PRELIMINARY/FINAL DRAINAGE REPORT FOR JUDGE ORR RANCHETTES

October, 2017

PCD FILE NO's: SP-17-011
SF-17-021

Basin ID: DP-P3

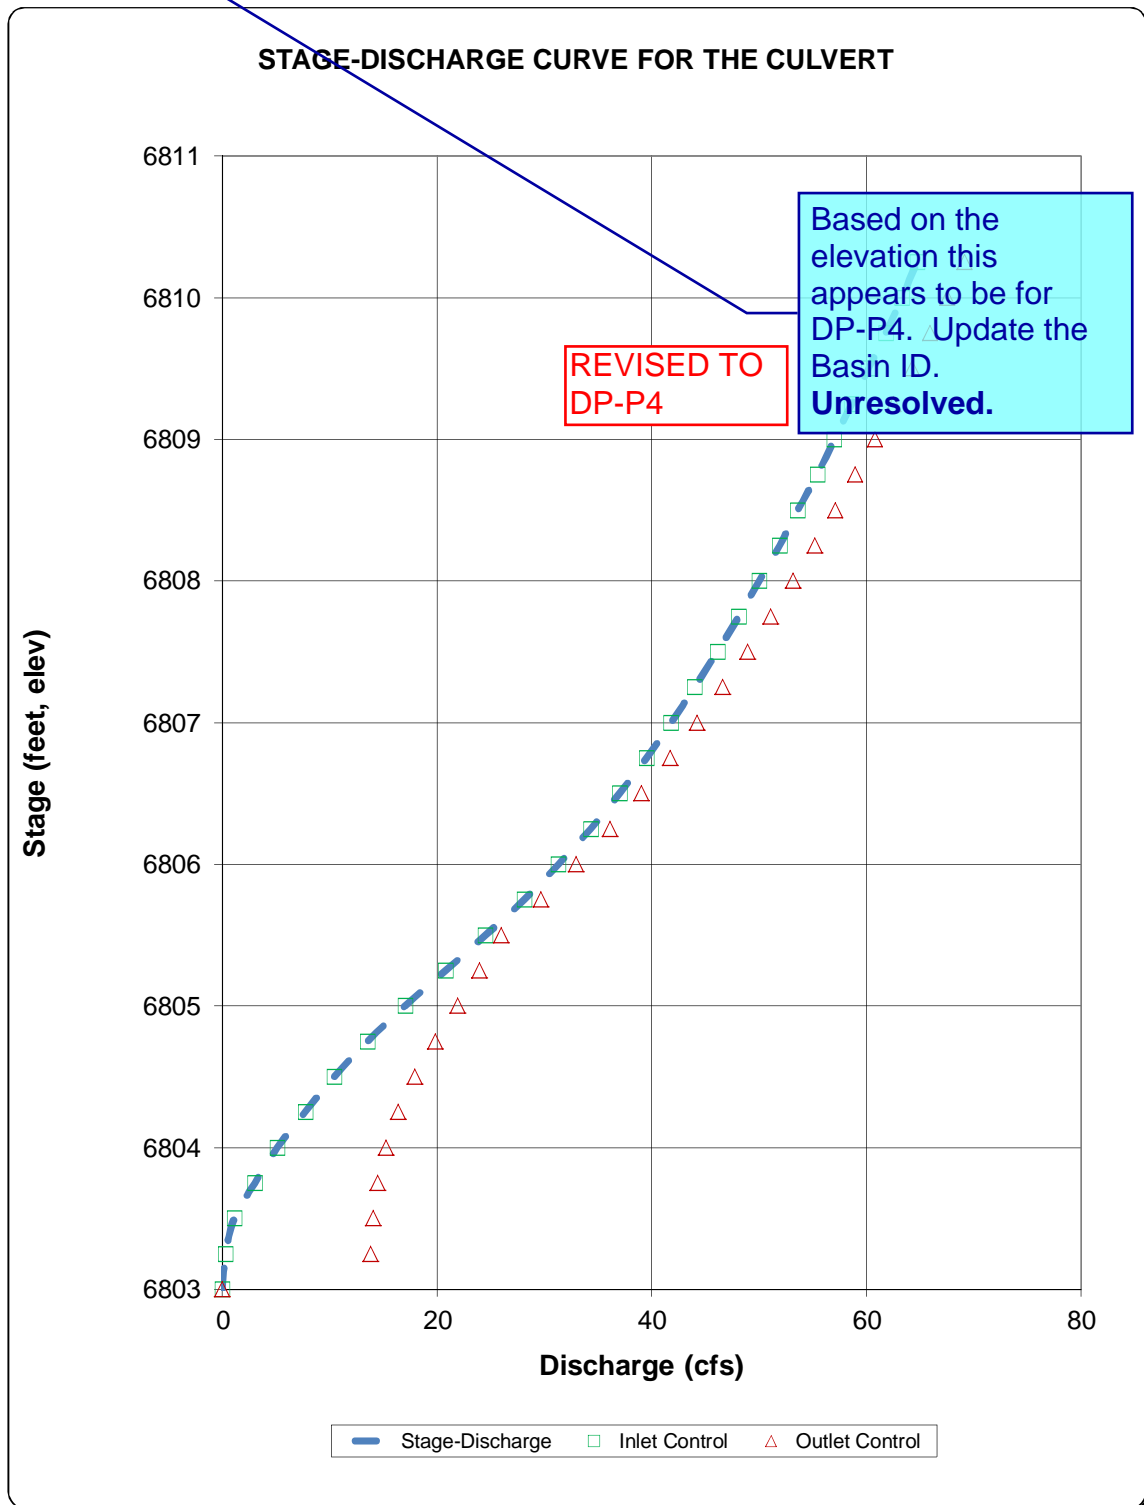
The outlet protection worksheet
is missing.

Culvert Calculation for Design Point P3 is missing.

OUTLET PROTECTION
ADDED

CULVERT CALC
FOR OFFSITE
30" RCP ADDED

PROPOSED DRAINAGE MAP

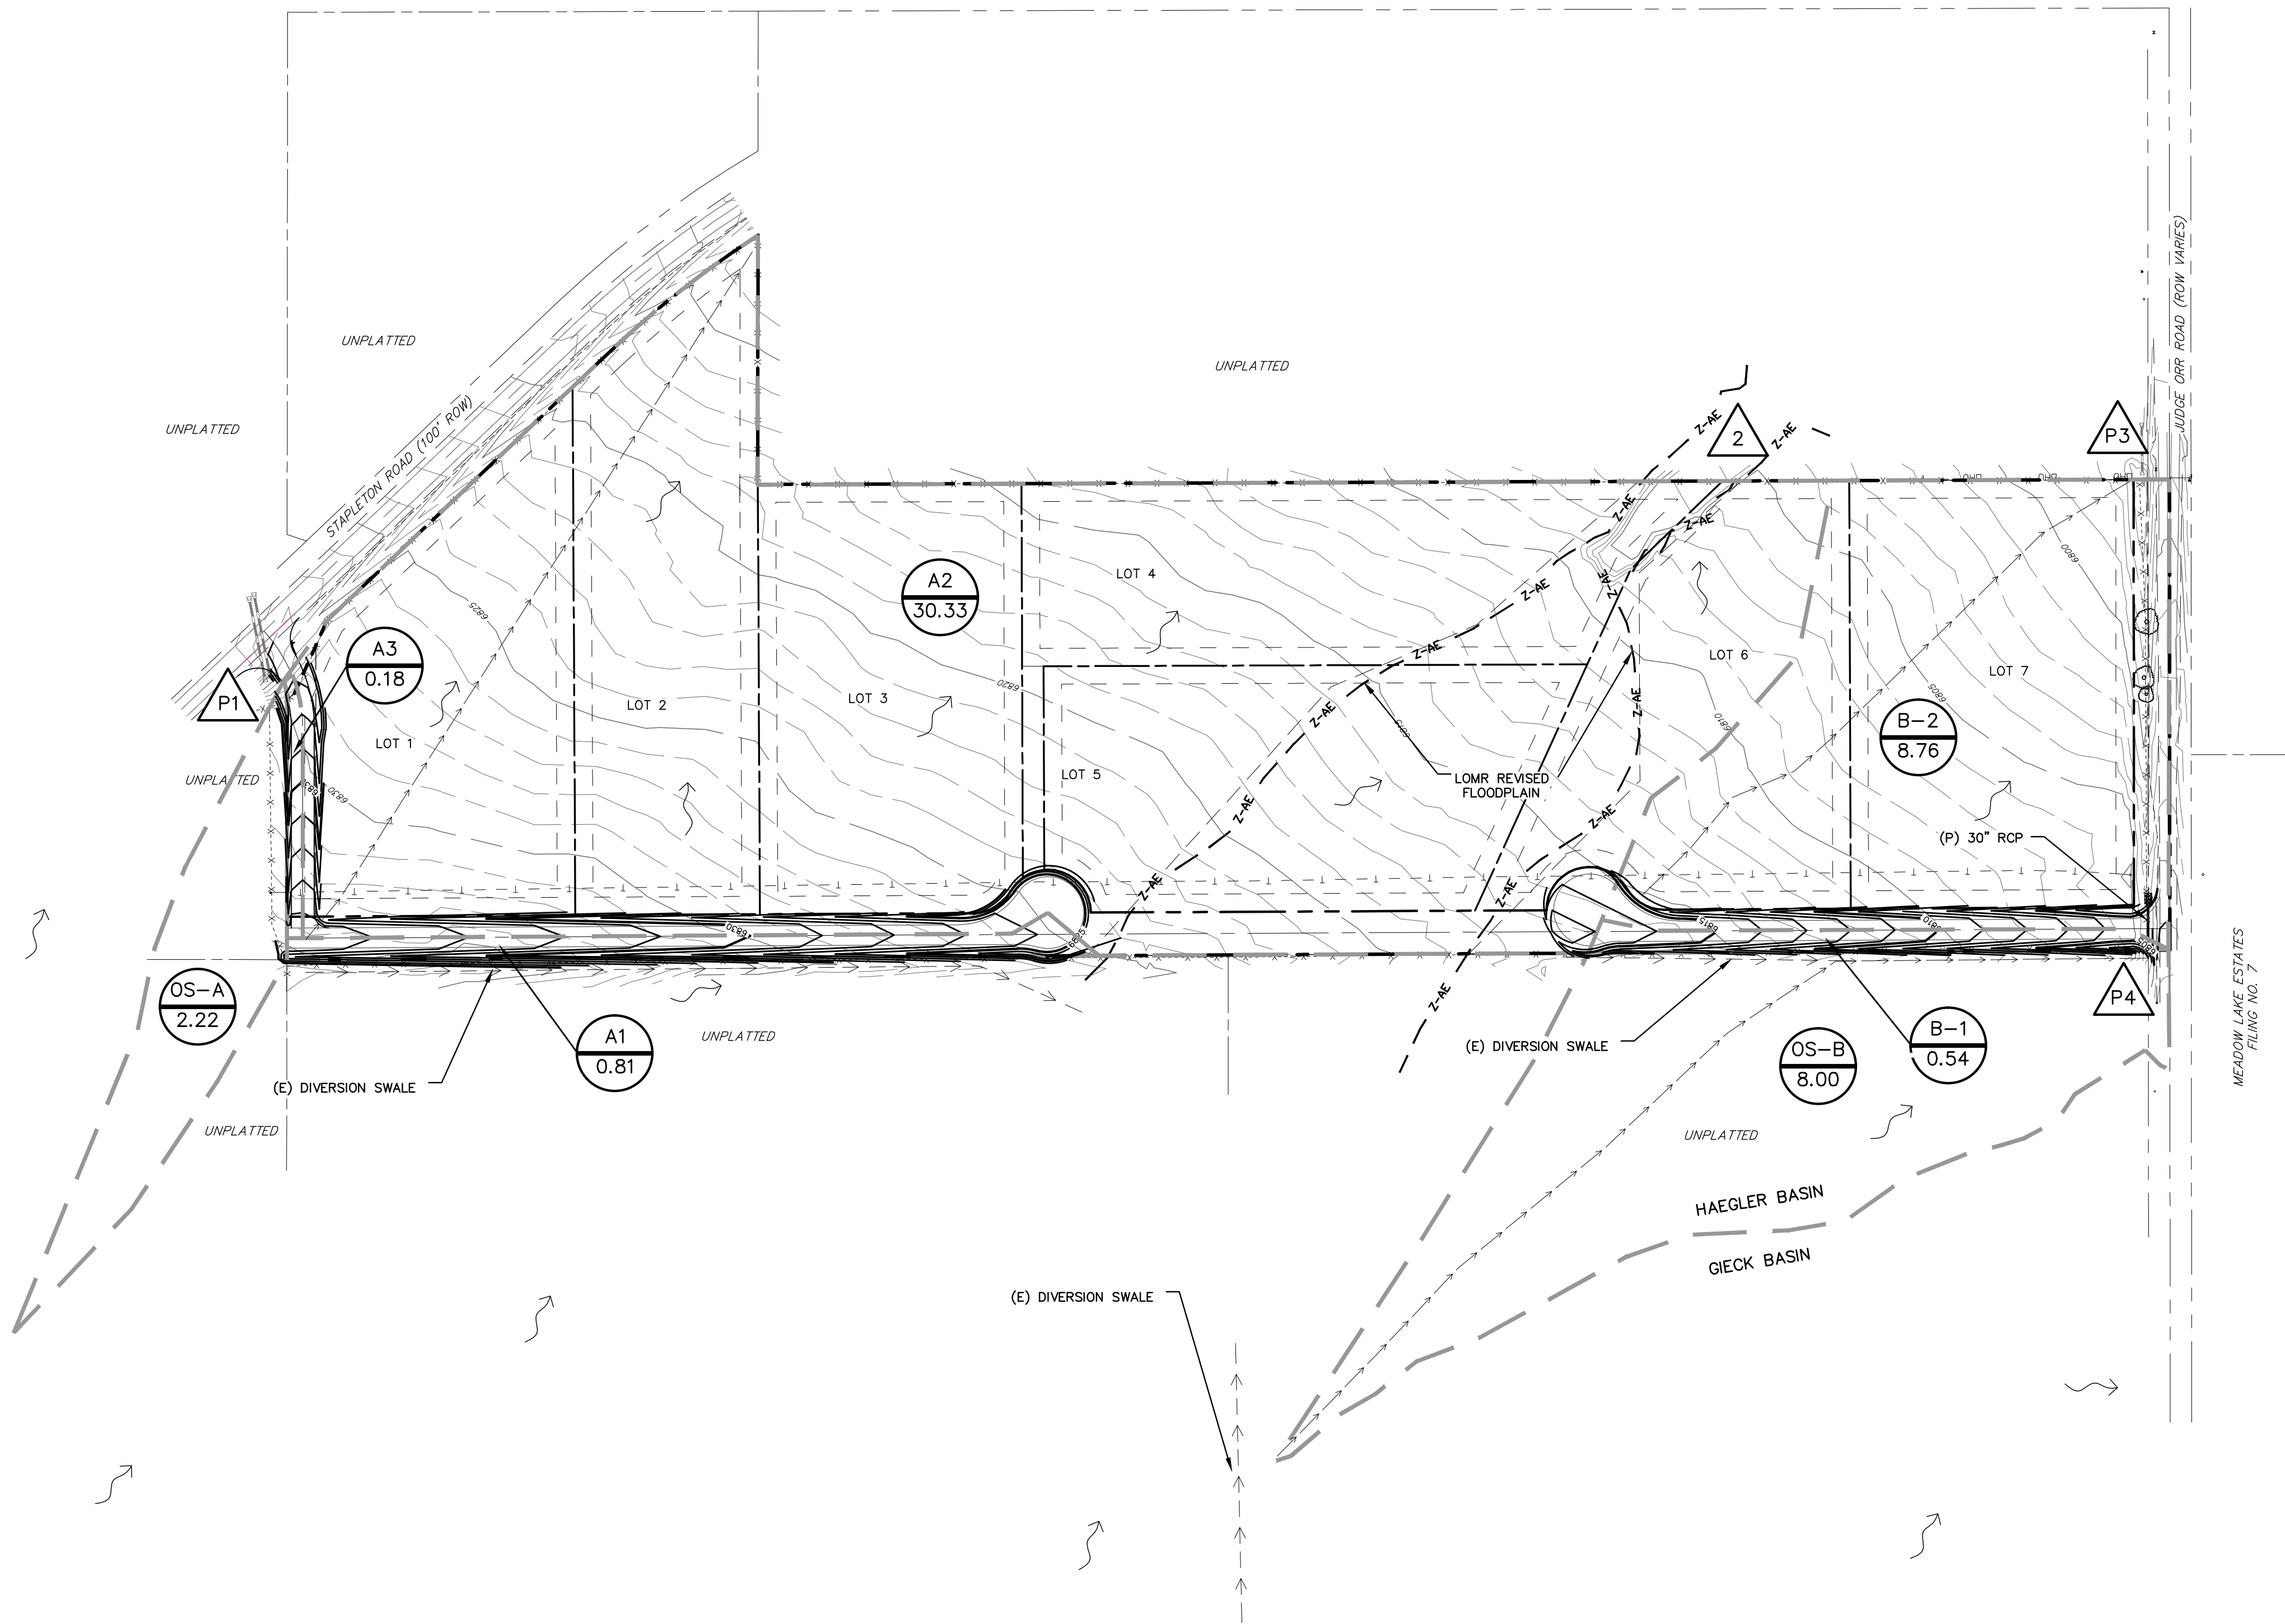
The drainage map shows an existing culvert at DP 3. Provide the calculation and analysis.

Further discussion added.
